Access Compliance Report Public Rights-of-Way (Pedestrian Signals)

Main Street: **NEWLAND_ST** Cross Street: **BOLSA_AVE** Location: **SW**

ADA ID: **SGRK210929130519** Signal Type: **One Push Button-Non APS** Overall Compliance: **No** Severity Scores: **BTN 1: 10** **BTN 2: N/A** **No BTN: N/A**

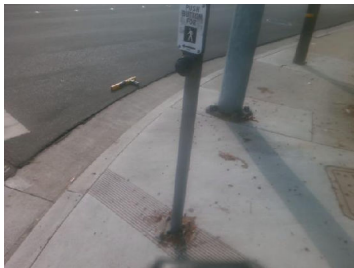
N/A	Is Button 1 APS or Non-APS?	NonAPS	N/A	Is Button 2 APS or Non-APS?	N/A
N/A	B 1 VibroTact Arrow?	N/A	N/A	B 2 VibroTact Arrow?	N/A
N/A	B 1 VibroTact Parallel to Xing?	N/A	N/A	B 2 VibroTact Parallel to Xing?	N/A
N/A	B 1 VibroTact Contrast	N/A	N/A	B 2 VibroTact Contrast	N/A
No	B 1 Pilot Light?	No	N/A	B 2 Pilot Light?	N/A
N/A	B 1 Pilot Light Illumination?	N/A	N/A	B 2 Pilot Light Illumination?	N/A
N/A	B 1 Walk Indicator Type	N/A	N/A	B 2 Walk Indicator Type	N/A
N/A	B 1 Walk Indicator Audible?	N/A	N/A	B 2 Walk Indicator Audible?	N/A
N/A	B 1 Locator Tone?	N/A	N/A	B 2 Locator Tone?	N/A
N/A	B 1 Tone Audible Range?	N/A	N/A	B 2 Tone Audible Range?	N/A
	B 1 Addl APS Features?	No		B 2 Addl APS Features?	N/A
	B 1 Addl APS Features Notes			B 2 Addl APS Features Notes	
		N/A			N/A

Possible Solutions: Replace Signal Push Button With APS Button.
